## **RC210404 – CLARIFICATIONS OF PROPOSAL PRIOR TO NOTIFICATION**

Southern Planning Group act for Larksbay New Zealand Trustees Limited (**Larksbay**) who are the owners and occupiers of Lot 1 Deposited Plan 387519. The site is located on the eastern side of State Highway 8, Cromwell.

The site is subject to resource consent RC210404 which seeks land use consent to establish a residential building platform and undertake associated earthworks which is referenced RC210404.

## **Landscape Addendum**

Figure 1 – ONL Line Illustrated in Blue. Source – Landpro.

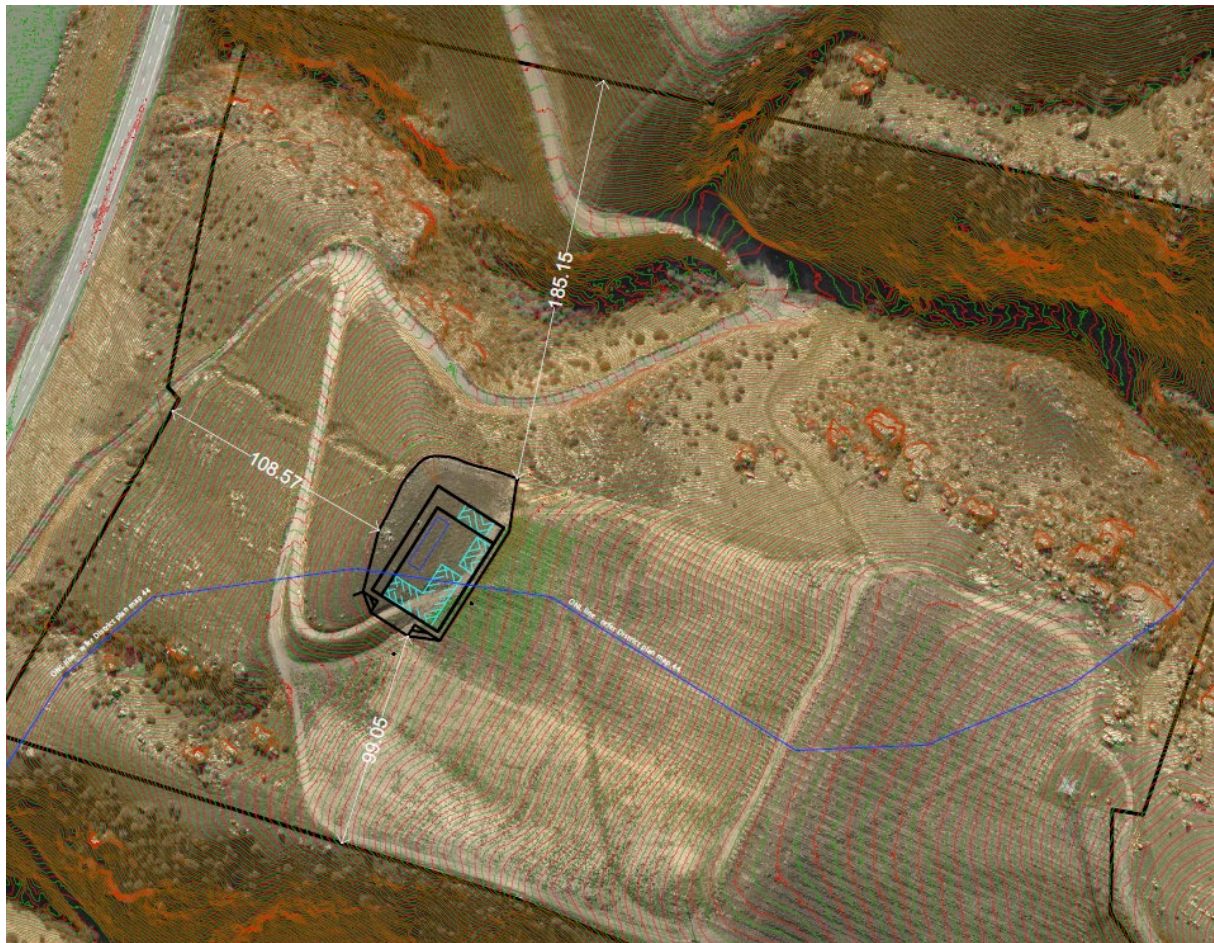
Following receipt of the S95 report and reviewing of Figure 1 in that assessment, the applicant requested that their surveyor's prepare plans accurately illustrating the ONL line from the District Plan maps. Upon receipt of that information, it became apparent that ONL line does in fact run through the building platform and proposed access as illustrated in Figure 1 below. Plans illustrating the ONL line in greater detail are attached as **Appendix [A]**.

Accordingly, the applicant confirms that the proposal seeks consent for a building platform and associated earthworks, within an ONL.

CROSS SECTION A  
A1 HORIZ SCALE 1 : 500  
A1 VERT SCALE 1 : 500

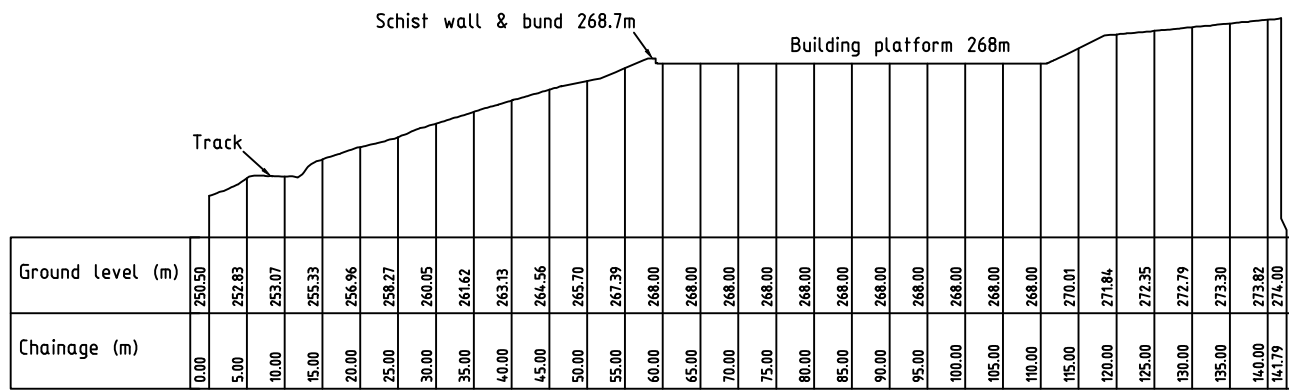
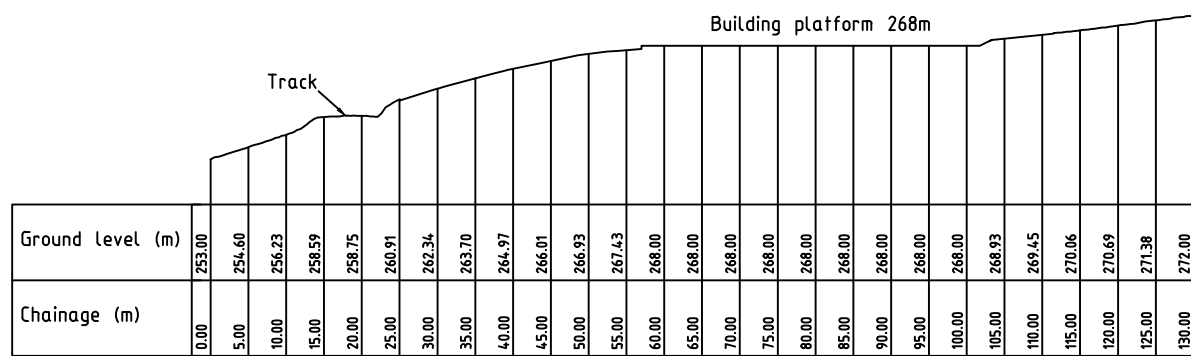
The plans in **Appendix [A]** illustrate the full extent of earthworks to reduce the entire building platform to the RL 268.0m and also includes cross sections of the proposed earthworks to enable a better understanding of the effects.

Figure 1

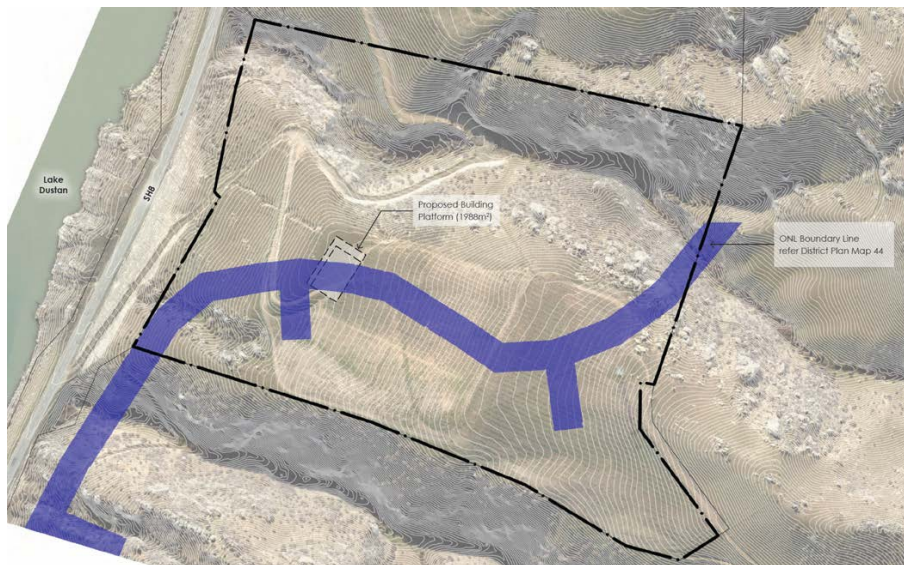
- 2 The Central Otago District Plan Map 44 and Map 52 shows the ONL boundary crosses the site, which would render the proposed BP partly in the ONL (Figure 1). Both registered landscape experts engaged in this application (Mike Moore for Council and Steve Skelton for the applicant) do not consider the ONL line as shown on Map 44 and Map 52 is appropriately located. The Patch Report considered that the ONL line *'more closely follows the upper edge of the gully, which is marked by the southern cadastral boundary.'*<sup>1</sup> Mr Moore's review of the Patch report states that *'the ONL boundary would make more landform sense if it followed the top of the gully form (more or less the property boundary).'*<sup>2</sup>

- 4 The ONL boundary shown in the District Plan maps is a thick (30m wide) line and when overlaid on the subject site, crosses perpendicular across a consistently graded slope (Figure 1) in an east west direction, before diverting to the north again near the cadastral boundaries and High Voltage Transmission Lines (HVTL). Much of slope which the line on the plan crosses is occupied by a vineyard. However, there is a clear and legible landscape line to the south of the vineyard where I consider (and it is understood Mr Moore considers) the ONL boundary exists (Figure 4). This boundary is most strongly demarcated by the landform transition between the consistently graded slopes to the north and the gully landform to the south (Figure 5). This landscape line is also legibly expressed by:
  - a. The strong geomorphological features (landform),

Figure 4

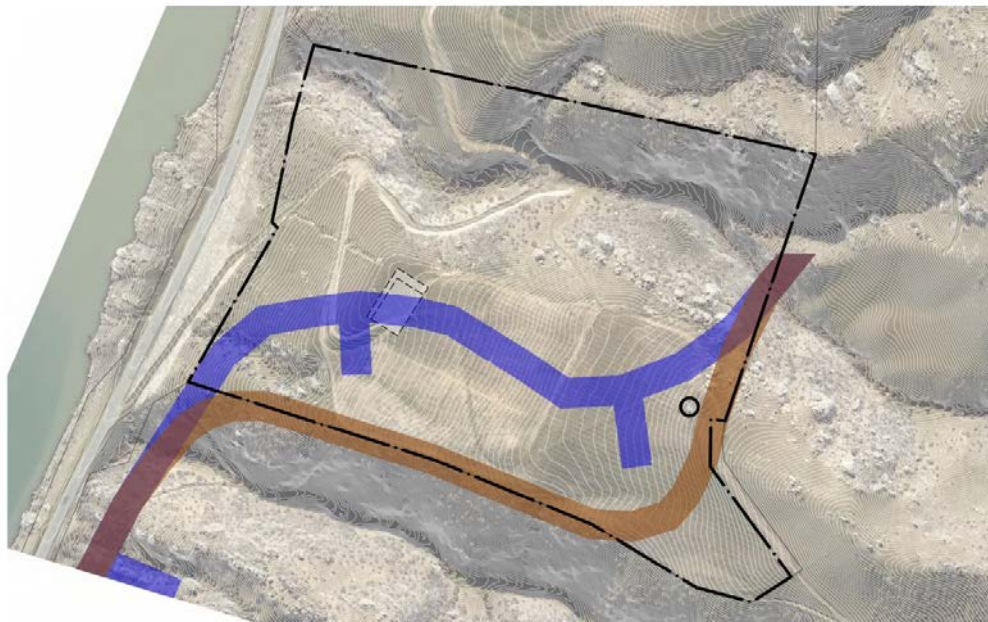
Expert assessment is not required to determine that the change in landscape values occurs at to the south of the proposed BP (Figure 4 and 5), not as that shown on the District Plan maps.
